Service Information:

Improvement of Torsional Vibration Damper

BMW Torsional Vibration Damper with Heatshield

Figure 1: Torsional Vibration Damper with Heatshield

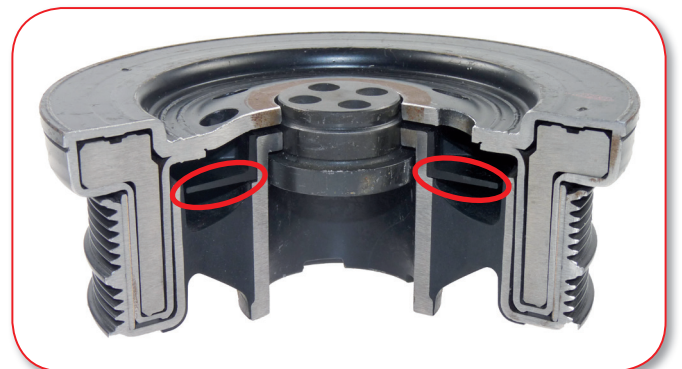
Pulley No.80001103 now features a thermal shield (see figure 1 below). Designed by the original manufacturer, this shield will protect the engine against failures of the first generation pulley which occurred due to high temperatures affecting the damping rubber.
